PROPOSED OFFICE BUILDING

111 MAPLEWOOD AVENUE
PORTSMOUTH, NEW HAMPSHIRE

PROJECT NO: K-0076-019

**TAC SUBMISSION
COMPLETE SET 30 SHEETS**

L-501

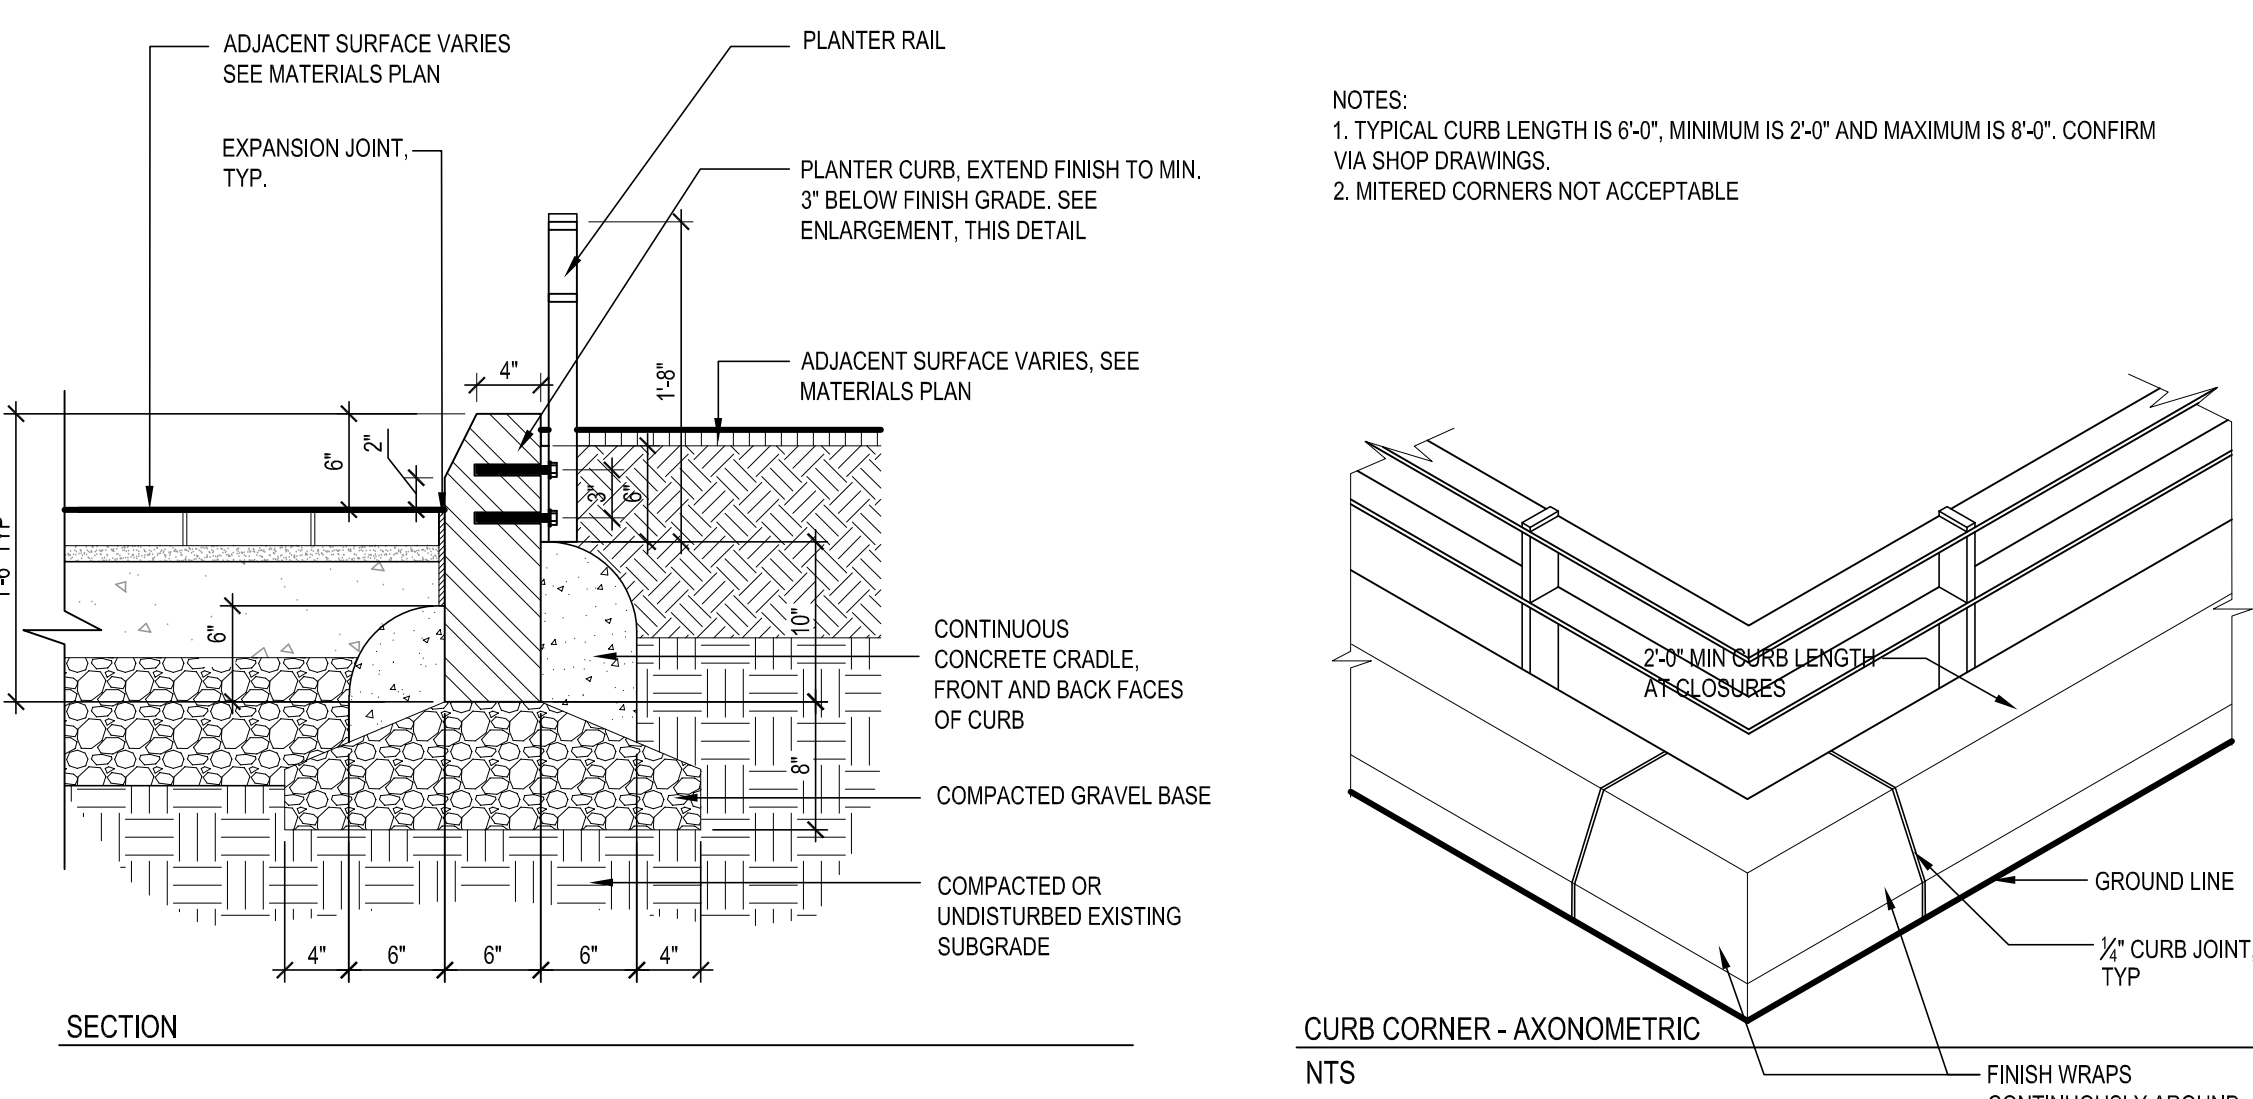
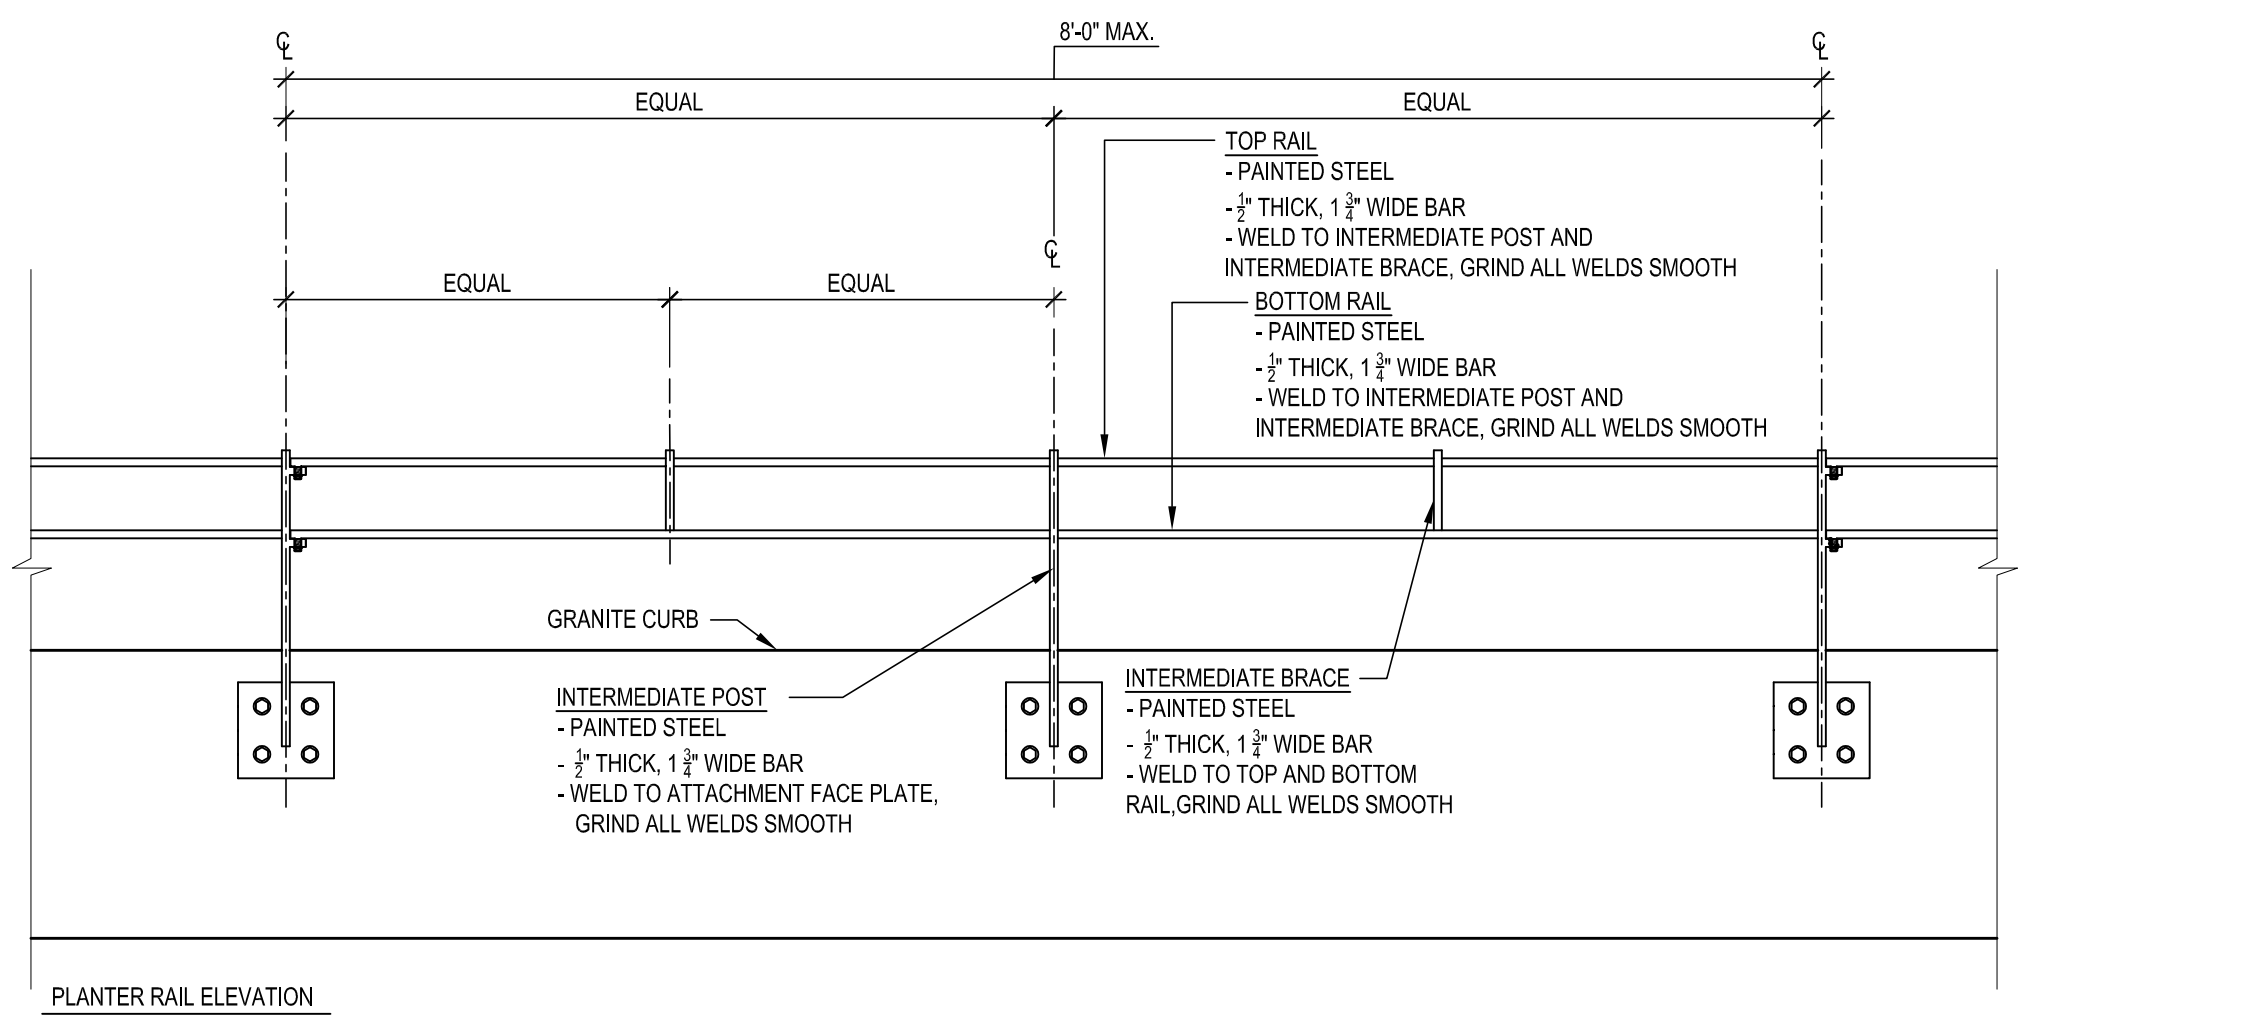
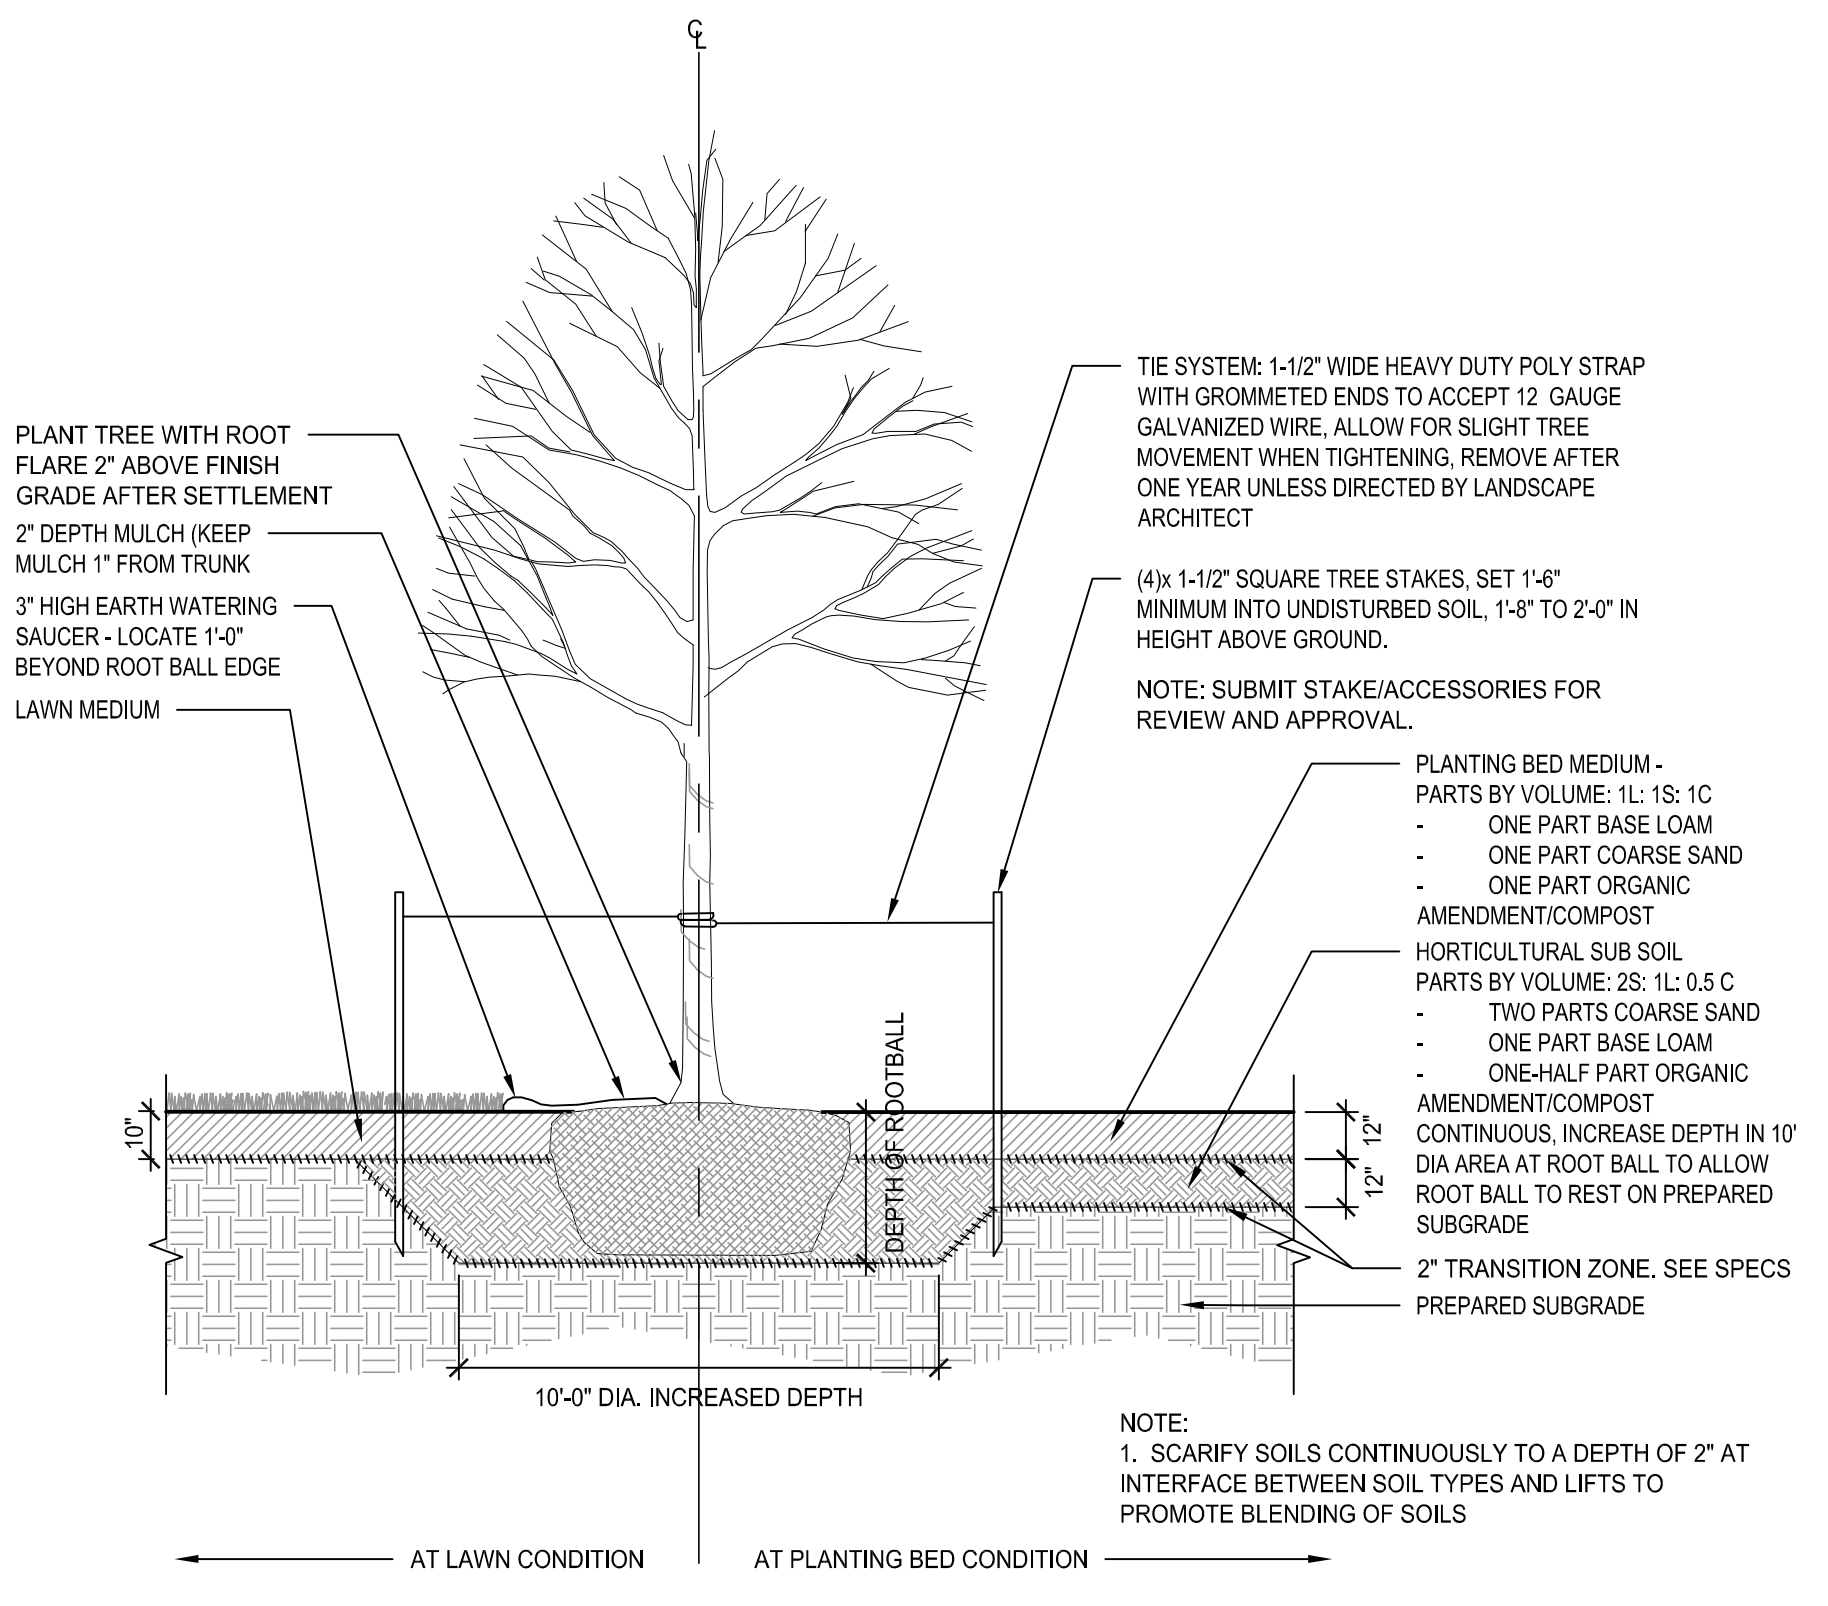
18	Confirm on-street loading zone designated from 6-9a on Vaughan Street will be needed for building operations. If necessary, on-street loading zone will need to go through Parking and Traffic Safety (PTS) Committee prior to Planning Board.	Confirmed, the applicant has requested to be placed on the next PTS agenda.	C-102.1
20	Low phosphorus, slow release nitrogen fertilizer to be specified on landscaping plan.	Note 2 on the Planting Notes indicates that low phosphorus, slow release nitrogen fertilizer to be used for planting beds.	L-501
